From: Scala, Mary Joy
Sent: Monday, April 23, 2012 5:07 PM
To: pastorhodari@gmail.com; Jessie Chapman (jessie@sketchwelldesign.com)
Subject: BAR Action 632 West Main Street

Certificate of Appropriateness Application (Deferred from March 20, 2012)

BAR 12-03-06
632 W Main Street
Tax Map 29 Parcel 1
Pastor Hodari Hamilton, Applicant/ First Baptist Church, Owner
Change window to door for emergency exit

**CITY OF CHARLOTTESVILLE
BOARD OF ARCHITECTURAL REVIEW
STAFF REPORT
April 17, 2012**

A GOOD
3-0 X 7-0 DOOR SET INTO EXISTING MASONRY OPENING WITH PANELS TO FILL REMAINING AREA.

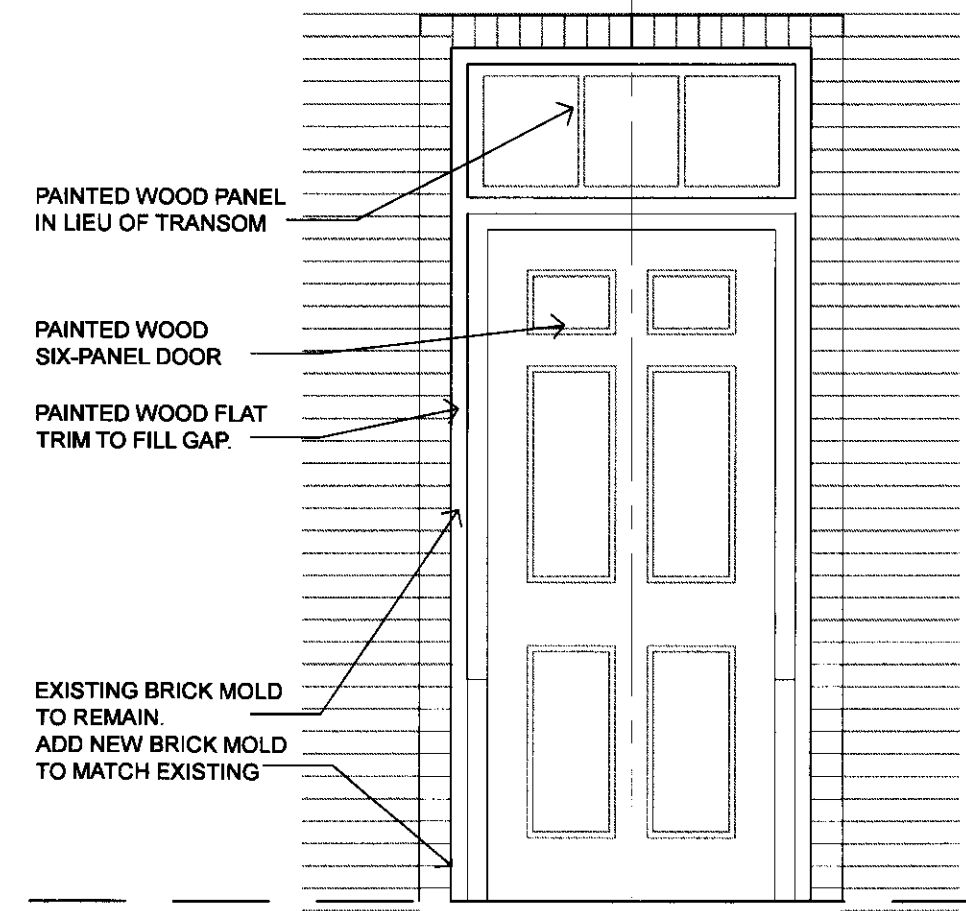
The BAR approved (9-0) the application to change a window into a door with the condition that transom glass back-painted gray be used. Options A and B are acceptable, but not C. A friendly suggestion was made to save/store the window.
